Access Compliance Report Public Rights-of-Way (Curb Ramps)

Main Street: AVENDALE_BLV		Cross Street: ZINNIA_ST		Location:	NE
ADA ID: RPRK21111170822	Ramp Type:Type 1 - Perpendicular	Initial Pass/Fail: Fail	Overall Compliance: No	Severity Score:	15
Codes/Mitigation Info/Possible Solution			Field Measurements/Component Compliance

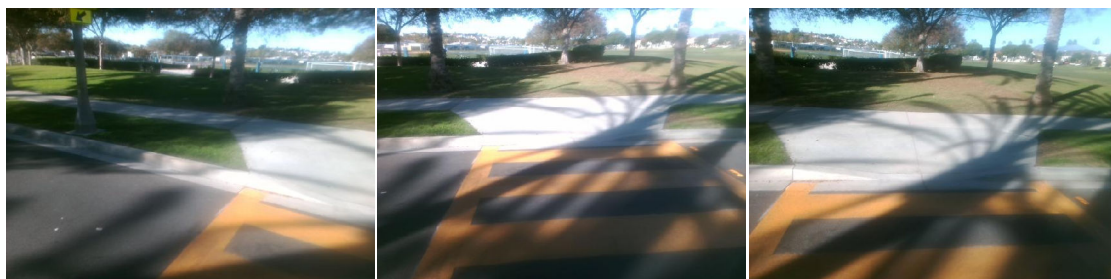
R304.2.2, R204.3, STD 1115

Remove & Replace Entire Ramp.
